[Docket No. 2001-NE-03-AD; Amendment 39-12097; AD 2001-02-12]

Airworthiness Directives; CFM International (CFMI) Model CFM56–7B Turbofan Engines

ACTION: Final rule; request for comments.

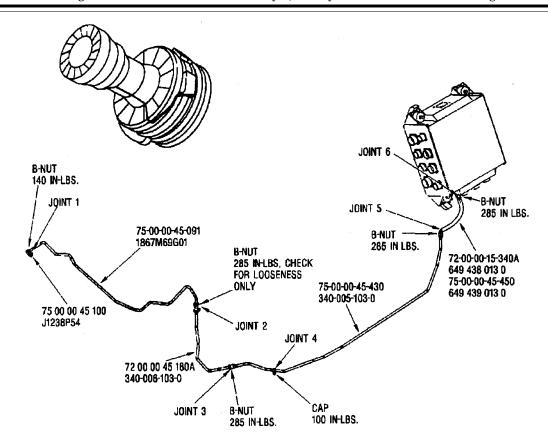
(a) Check for and apply the correct torque in the tightening direction of all PS3 pressure line fittings as identified in Figure 1 of this AD as Joint 1, Joint 2, Joint 3, Joint 4, Joint 5, and Joint 6 as follows:

- (1) Torque Joint 1 to ensure a torque value of 140 inch-pounds.
- (2) Due to accessibility limitations, check Joint 2 for finger looseness, and only if loose, torque to a value of 285 inch-pounds.
- (3) Torque Joint 3, Joint 5, and Joint 6 to ensure a torque value of 285 inch-pounds.
- (4) Torque Joint 4 to ensure a torque value of 100 inch-pounds.
